THESE PLANS have been examined for compliance with the Ontario Building Code Requirements. A Building Permit is in Order to issue subject to any changes noted under the condition that the building will be constructed in accordance with the code

WILLOW 3E (GR)
ELEVATION 1, 2 & 3

TITLE SHEET
BARLASSINA CONSTRUCTION
CITY OF CAMBRIDGE

MODEL:	
	WILLOW 3E	
	SCALE:	
	3/16"= 1'-0"	
	PROJ. No.	DWG. No.
	21-35	0

INVERTED STEEL ANGLE DETAIL

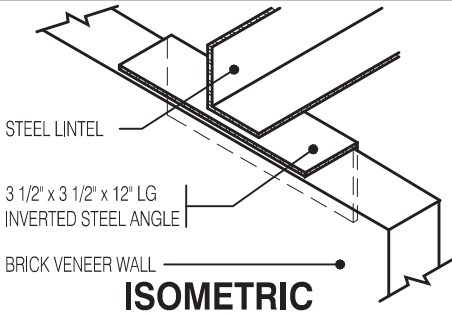
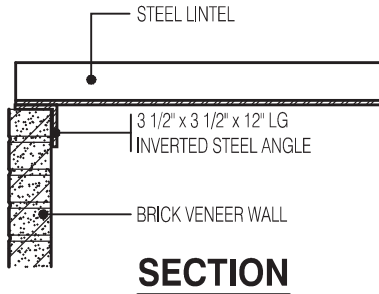
PROVIDE P.ENG APPROVED TRUSS & FLOOR DRAWINGS AND SPECIFICATIONS TO BUILDING INSPECTOR AT FRAMING INSPECTION

INSTALLATION OF FLUSH STEEL BEAMS SHALL CONFORM TO THE REQUIREMENTS OF 9.23.9.2.(3), (4) & (5)

P.ENG SOILS REPORT MAY BE REQ'D TO CONFIRM BEARING CAPACITY OF SOILS. SEE FIELD INSPECTOR

BASEMENT PLAN EL-2
BARLASSINA CONSTRUCTION
CITY OF CAMBRIDGE

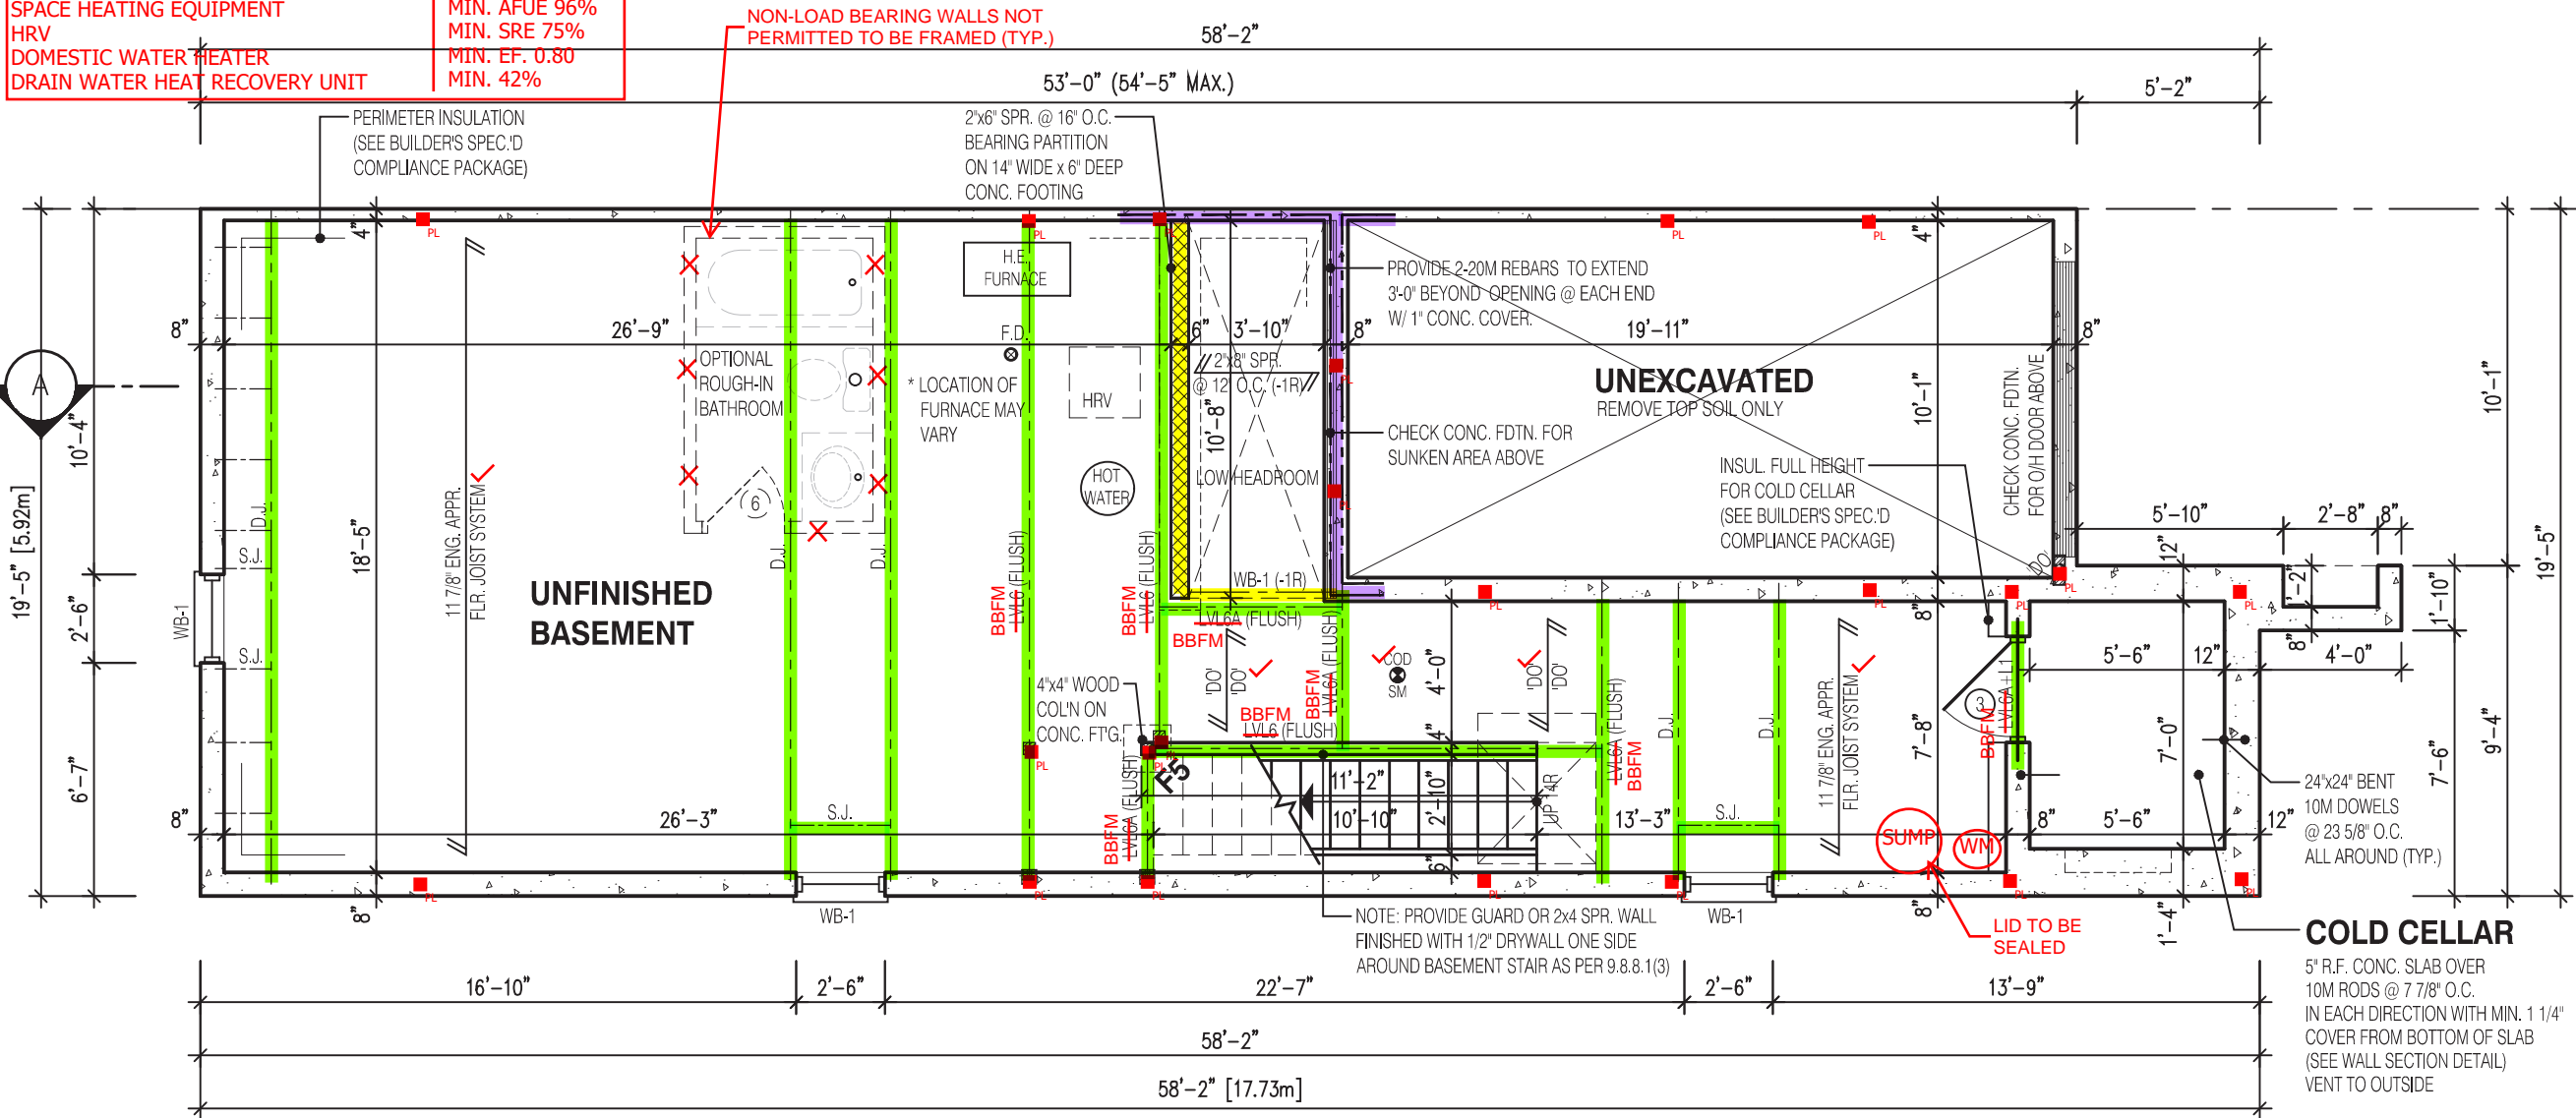
VERIFY WATER METER AND DWHR
UNIT LOCATION WITH INSPECTOR

SPRAY FOAM/RIGID INSULATION TO BE
PROTECTED AS PER 9.10.17.10.(1)

WATER METER TO BE INSTALLED WITHIN 2m
(6'-6") FROM THE POINT THE WATER SERVICE
PIPE MEETS THE BUILDING LINE

REQUIRED CONTINUOUS INSULATION
CANNOT BE INTERRUPTED BY FRAMING
MEMBERS SUCH AS STUDS

SEC. FLOOR PLAN EL-2
BARLASSINA CONSTRUCTION
CITY OF CAMBRIDGE

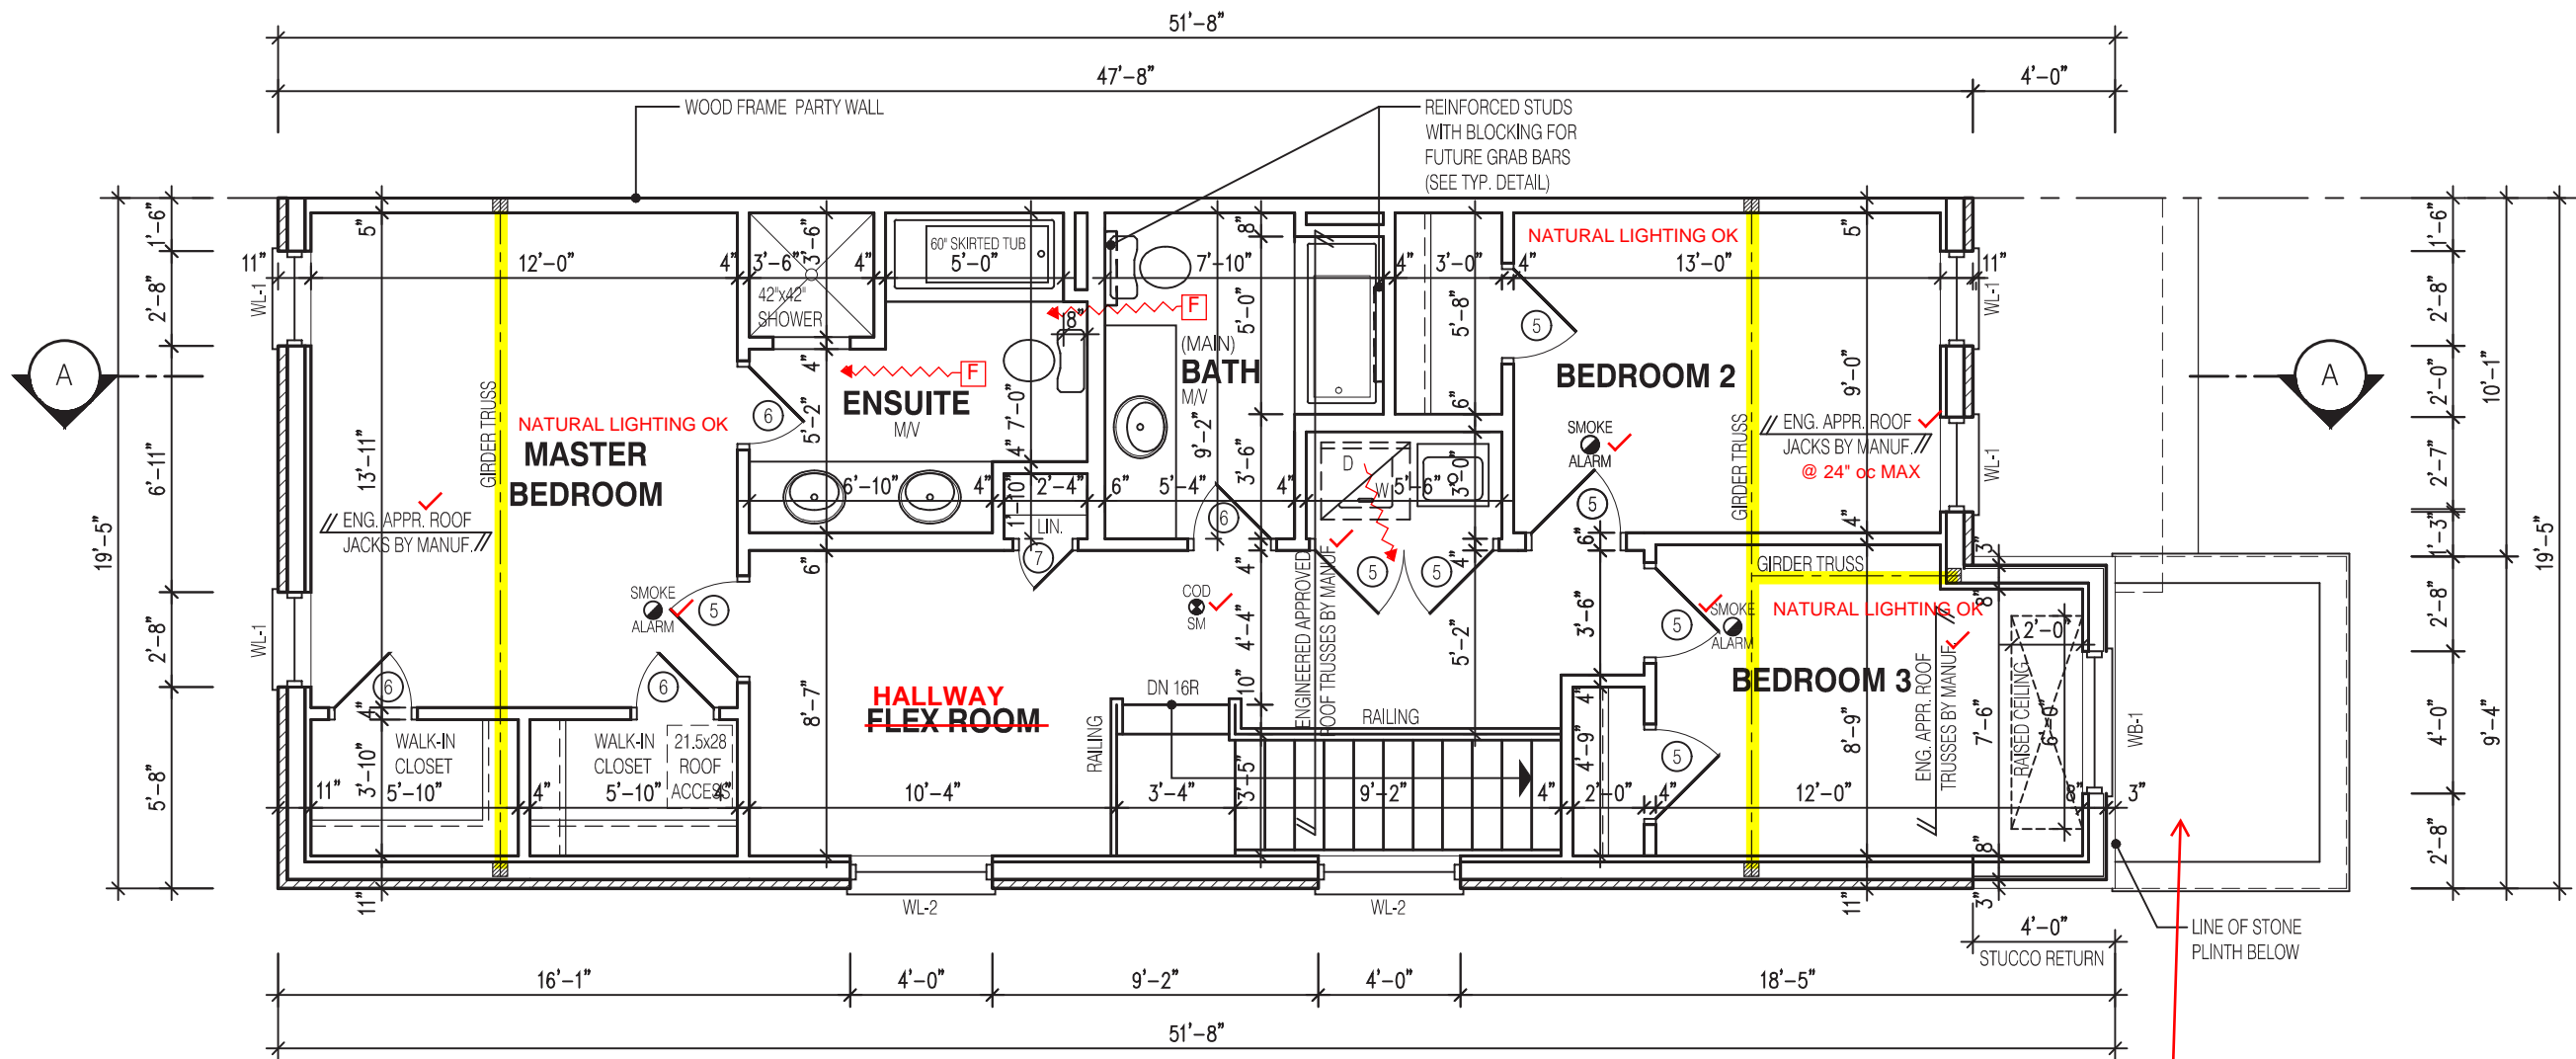
1 WINDOW SHALL PROVIDE AN UNOBSTRUCTED AREA OF 3.8SF w/ NO DIMENSION LESS THAN 15". WINDOW SILL TO BE MAX 39-3/8" ABOVE FINISHED FLOOR.

FLAT ROOF MEMBRANE CONFORMING TO T-9.26.2.1.B OR HAVE A CCMC OR BMEC APPROVAL FOR USE IN ONTARIO. MINIMUM ROOF SLOPE TO COMPLY WITH T-9.26.3.1.

LEFT SIDE ELEVATION 2
UNPROTECTED OPENINGS

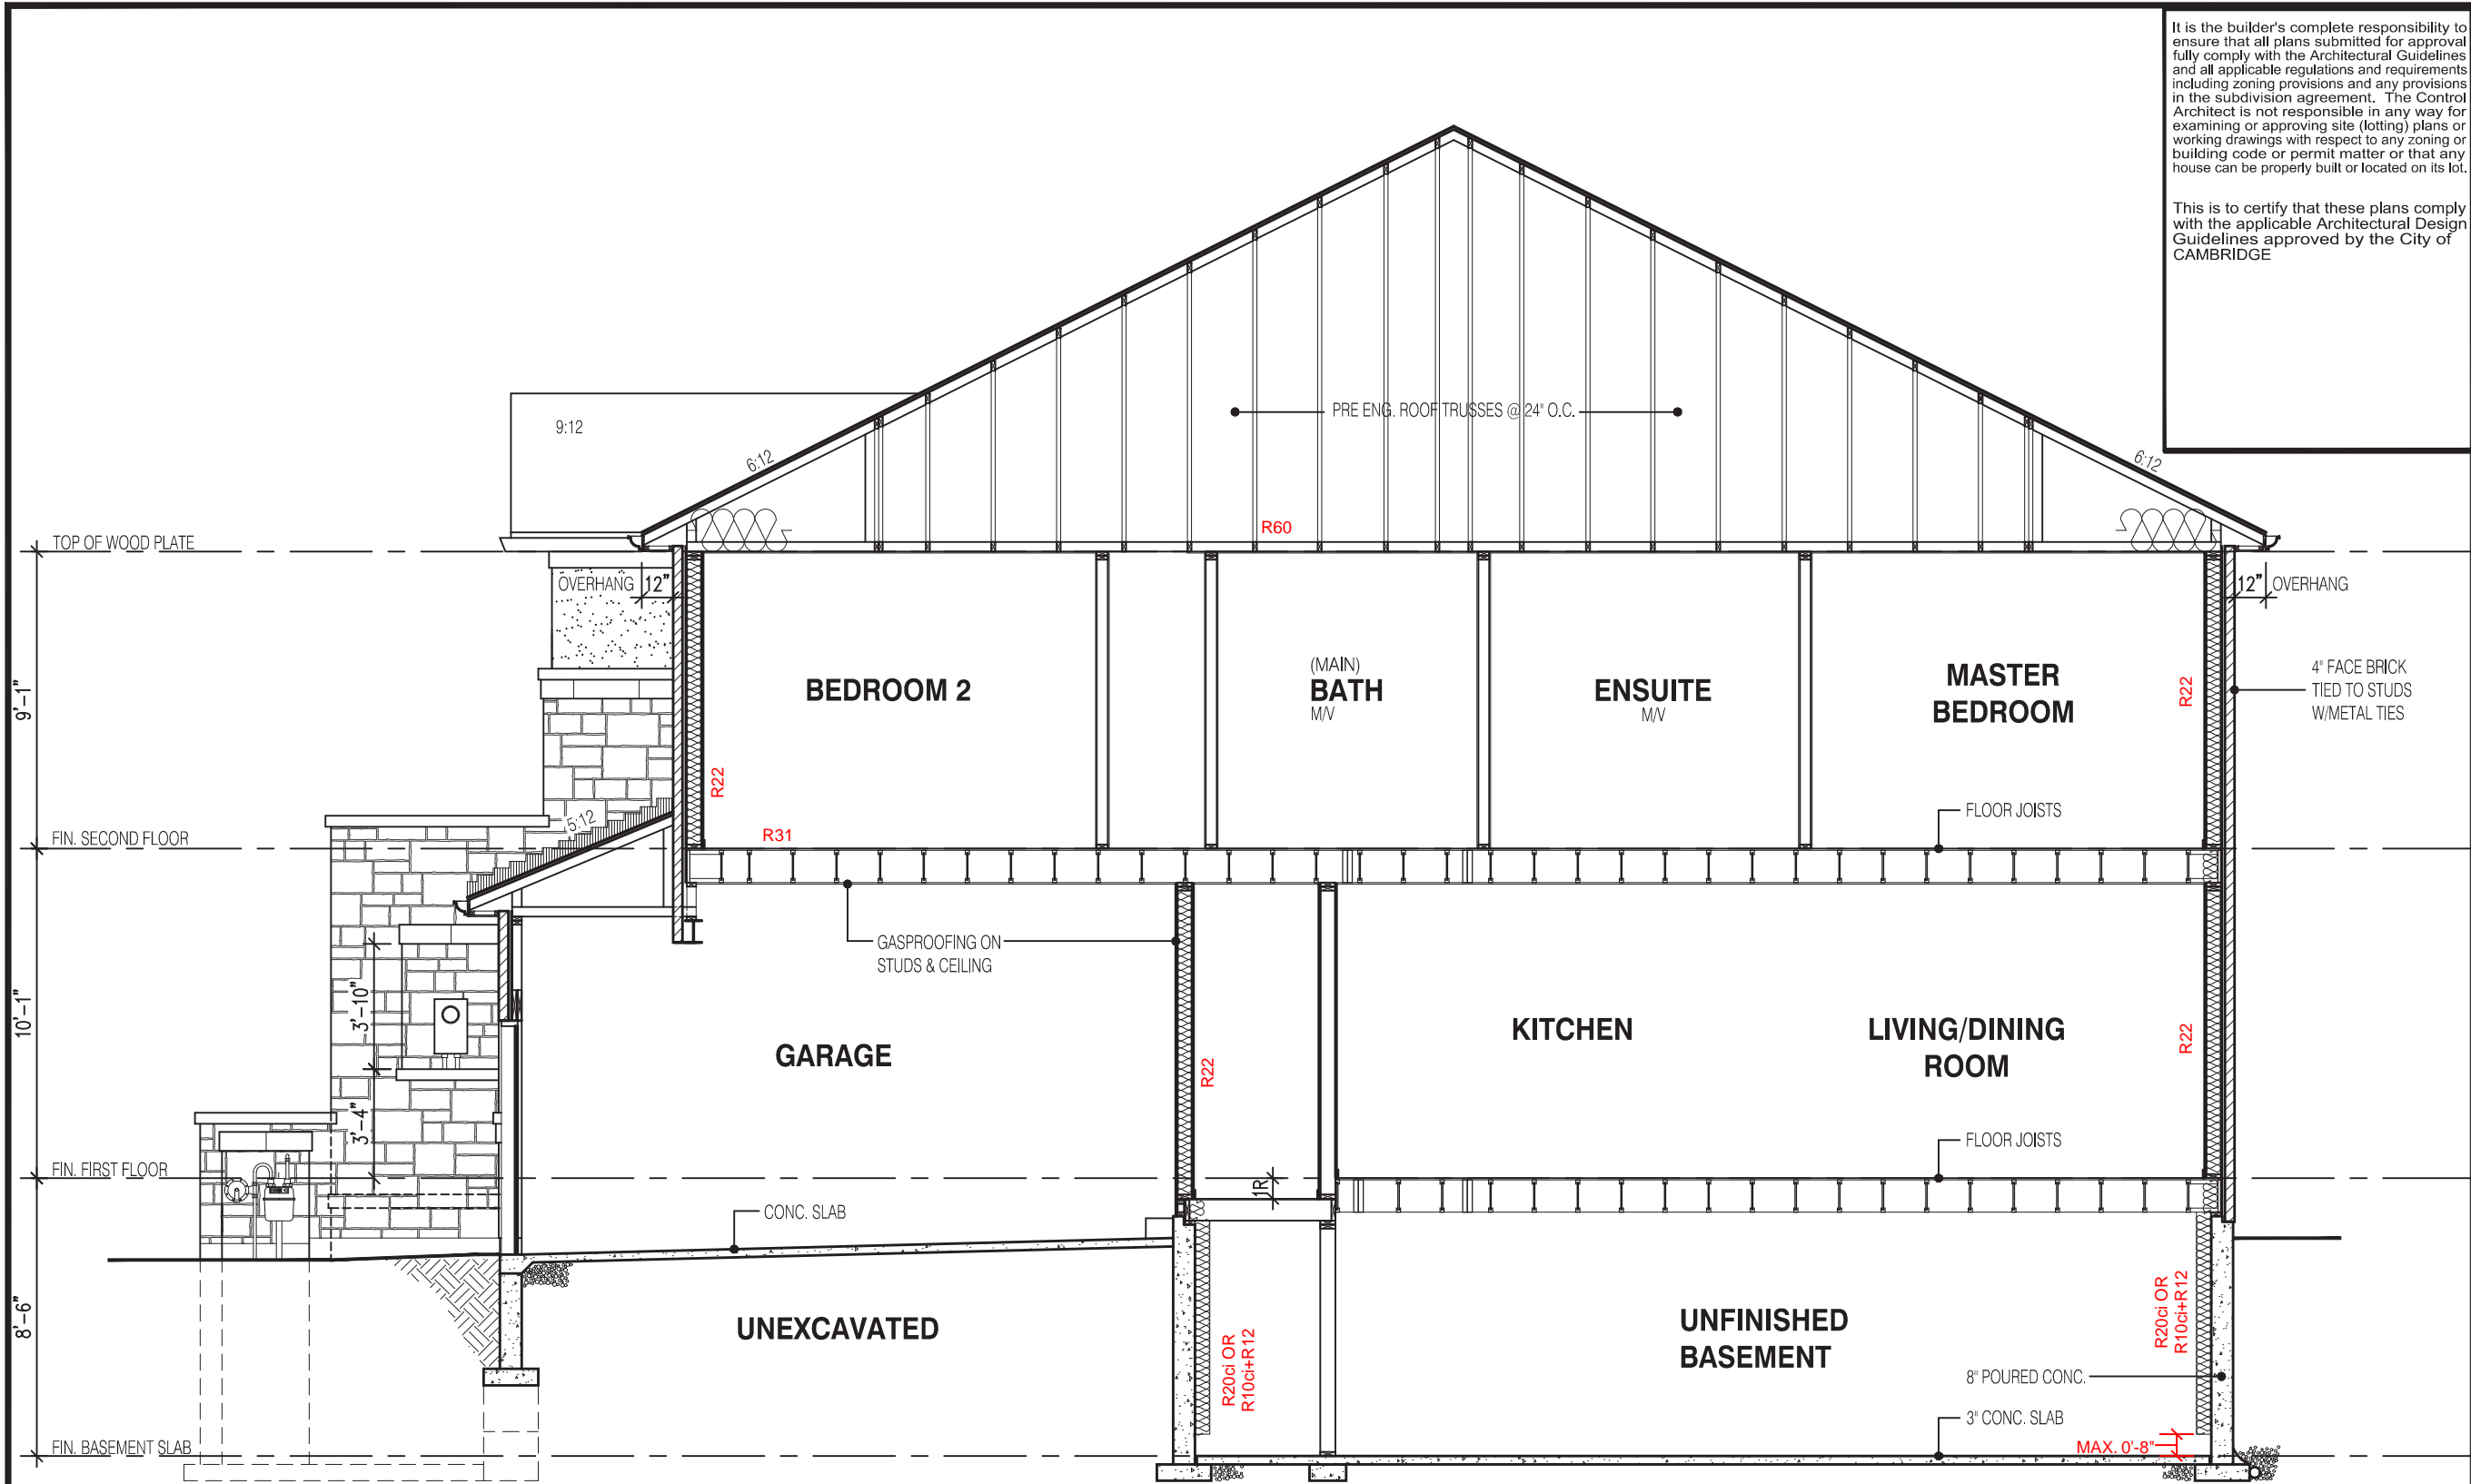
1188 Φ
83.16 Φ ✓
~~71.60 Φ~~
60.91 ✓

~~UNPROTECTED OPENINGS (WITH OPT. 30" x 24" WINDOWS)~~

~~ENLARGED WINDOWS NOT
SHOWN ON THIS ELEVATION~~

~~1188 Φ
83.16 Φ
75.00 Φ~~
